SAFETY EVALUATION  
OF THE GEOLOGIC FEATURES  
AT THE SITE OF THE SAN ONOFRE NUCLEAR  
GENERATING STATION

Docket Nos. 50-206  
50-361  
50-362

U. S. NUCLEAR REGULATORY COMMISSION  
Office of Nuclear Reactor Regulation

July 8, 1975

Figure 2

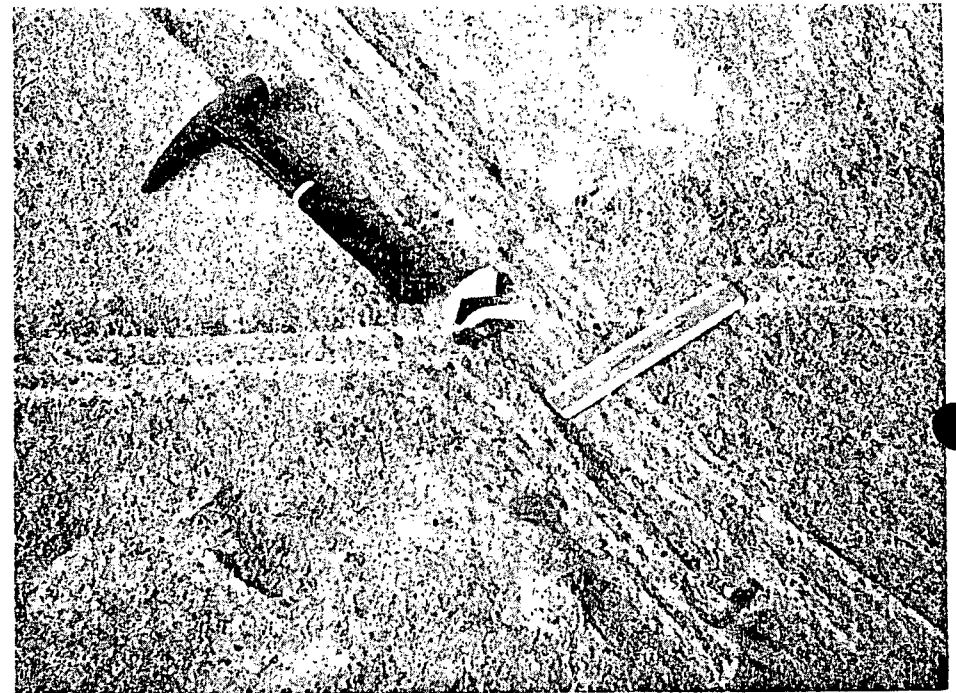
Where the two sets of shear zones intersect, each offsets the other. The maximum total displacement at their intersections and across clay inclusions has been observed not to exceed 4 inches (See Photos 2, 3, and 4). The sense of displacement is consistently left lateral for the Type A shears and right lateral for the Type B shears, indicating the development of a conjugate set of fractures.

Figure 6  
Landward or North Face of the Seacliff  
Exposure showing apparent fault.

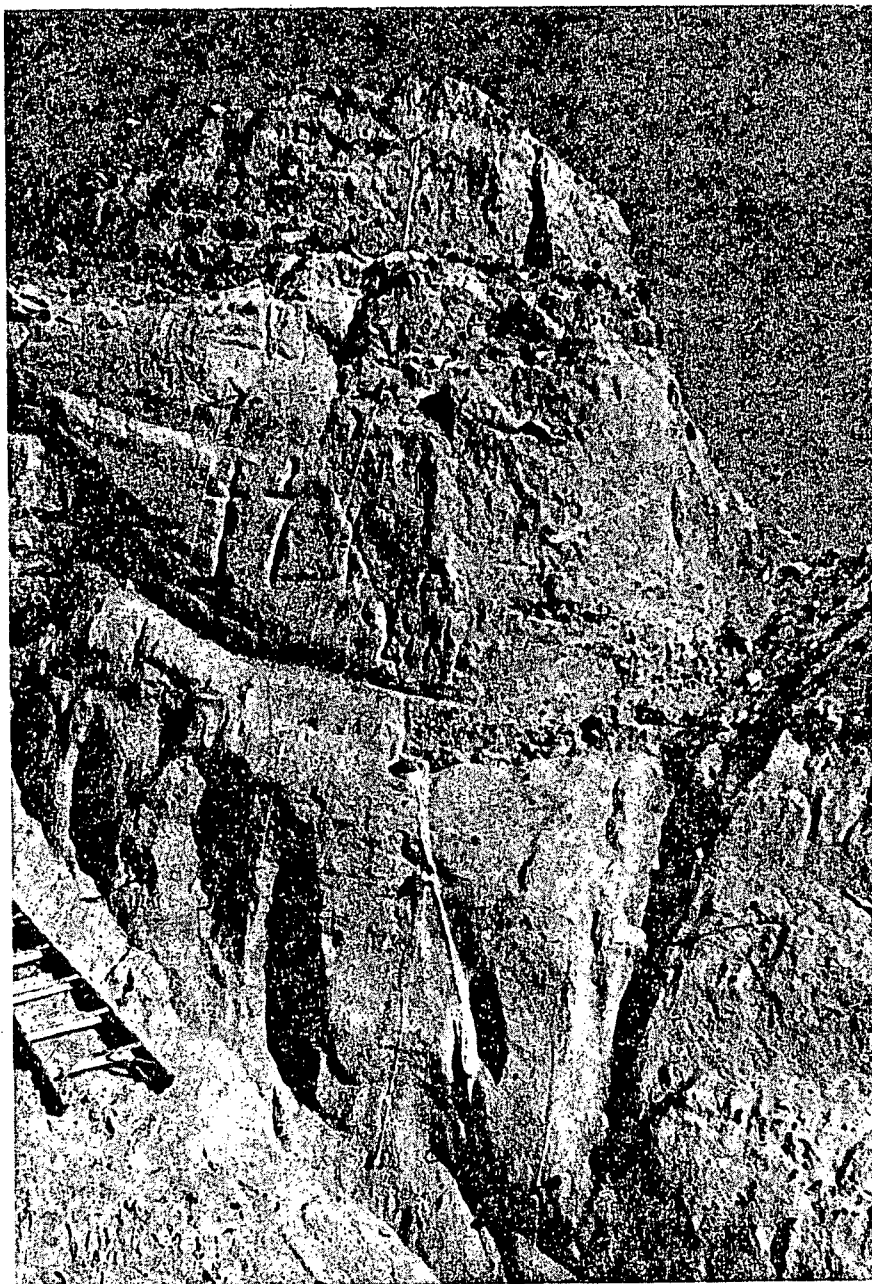
The alignment of the contact between Qm on the San Mateo Formation conveys the initial impression that the terrace deposit (Qt<sub>1</sub>) to the right of the shear alignment, (see upper right of Photo 6), is displaced downward. Photos 7 and 8 are closeup views of the shear zone-terrace contact from the landward and seaward sides, respectively. The photos show the shear zone to be clearly truncated by the marine terrace deposit (Qm). Wherever the shear zones are observed to intersect the terrace deposits - San Mateo Formation contact, no offset of the contact is visible.

Detailed geologic mapping of the seacliff, where the apparent terrace offset was found, showed that the shear zone was capped by the marine terrace deposit (Qm) (Photos 7 and 8) which is locally present in this area.

Figure 11  
Face of erosional contact between the marine terrace and San Mateo Formation after excavation of the marine terrace materials. Page 24

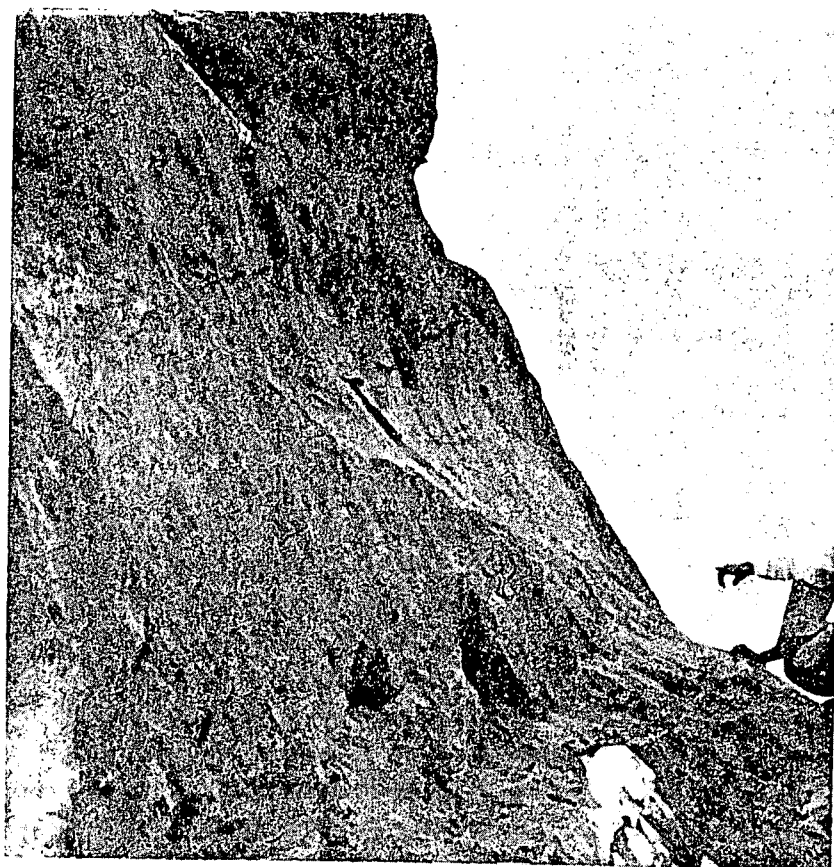
Upon careful removal of the marine terrace deposit, it was found that the plane of contact between the marine terrace deposit and the San Mateo Formation was irregular, as shown in Photos 11 and 12. This confirms that the plane of contact which initially appeared to be a fault plane is an erosional surface (Photo 12). Representatives from the staff and the USGS were present when the marine terrace contact was exposed by excavation and concur with the applicant's interpretation that the contact is of erosional origin. We conclude that the marine terrace deposit (Qm) materials were deposited in an erosional channel developed within the San Mateo Formation.
